ADDENDUM NUMBER 04

PROJECT: **CHEAHA STATE PARK FIRE STATION**

PROJECT NUMBER: **ASPD PROJECT #: 2026-005-16FS**

This Addendum forms a part of the Contract Documents and modifies the Bidding Documents dated **April 17, 2026**.

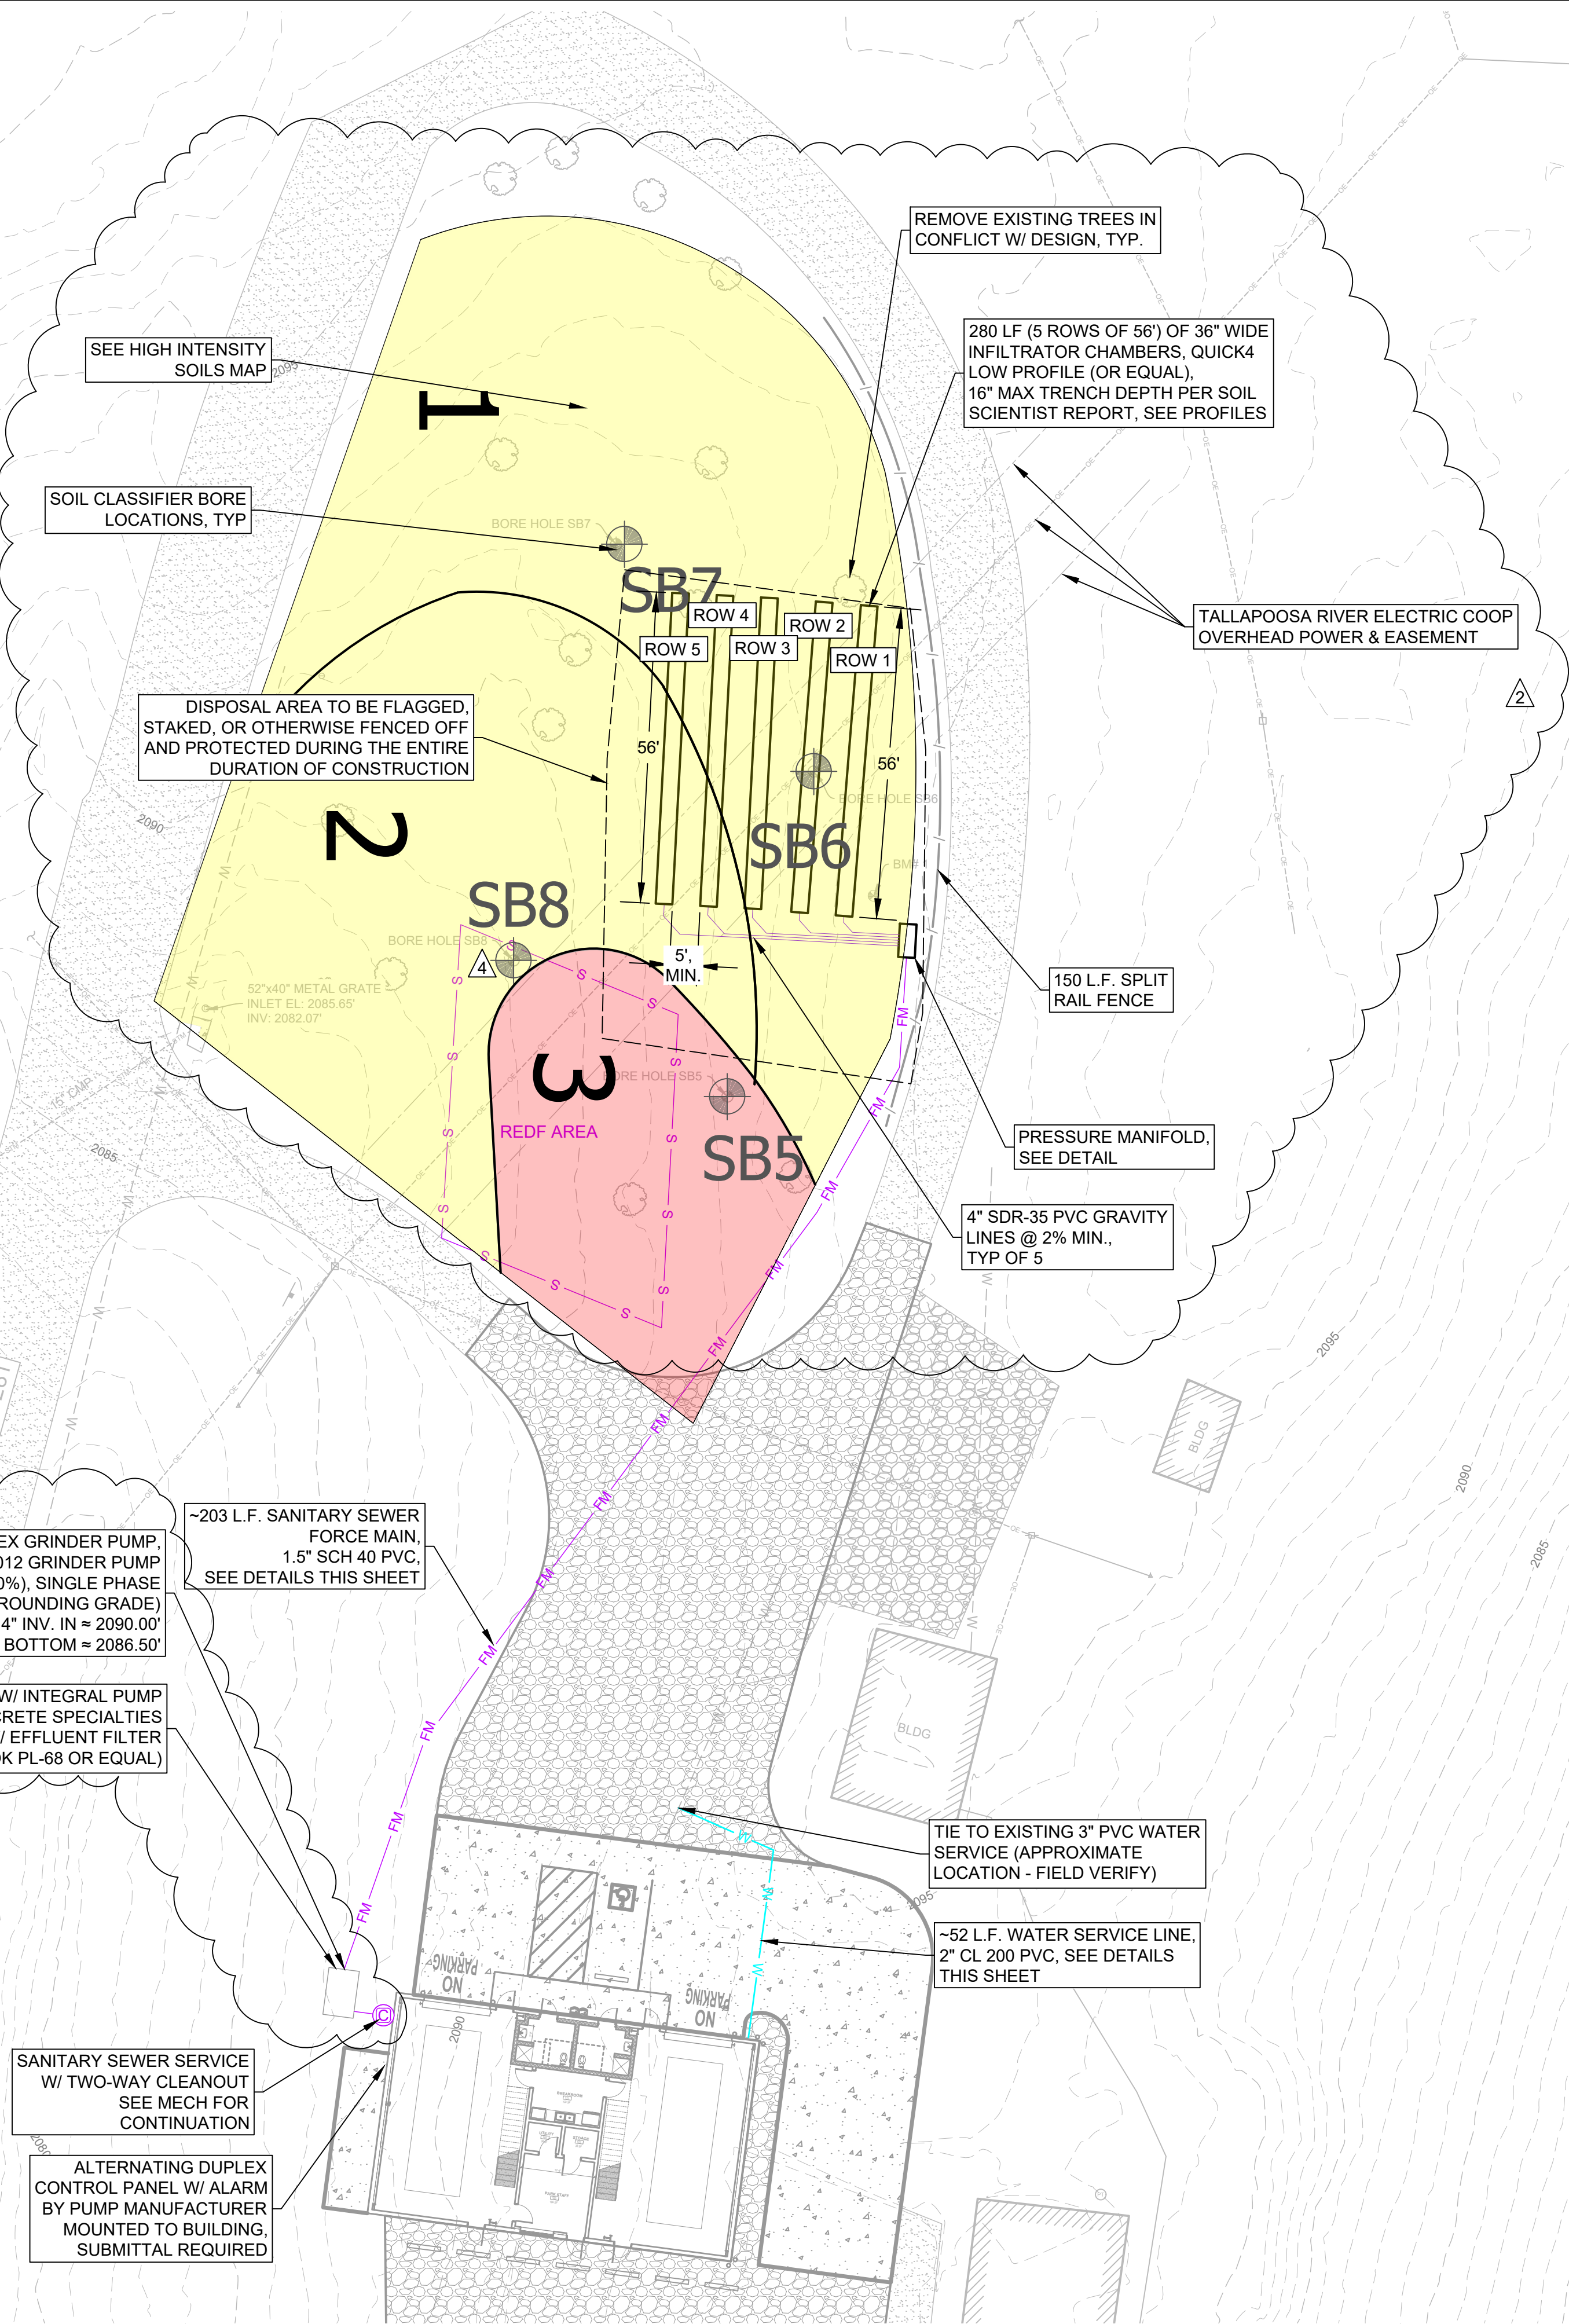
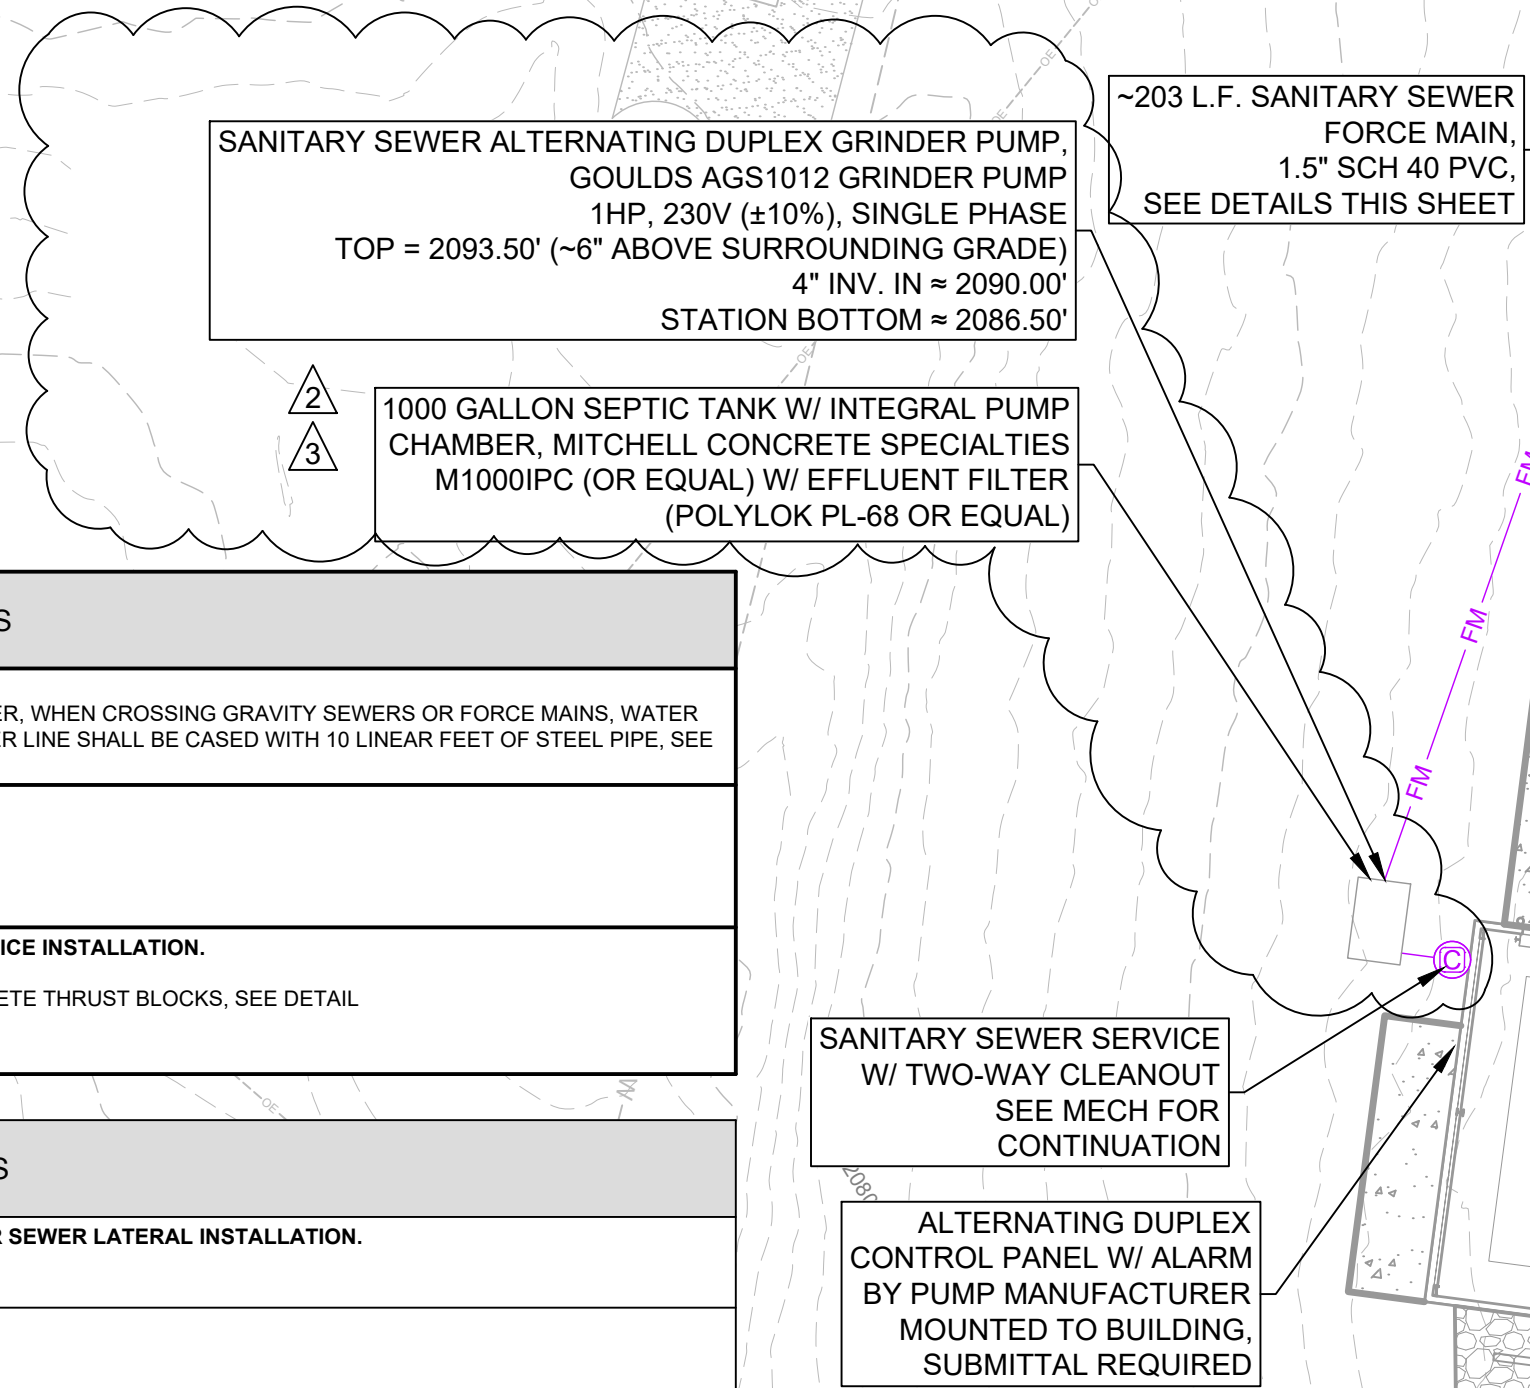
1. **Sheet C-302A – UTILITY PLAN**
 - a. Replace with the attached revised drawing.
 - b. Soils & soil bore locations updated according to Health Dept. comments
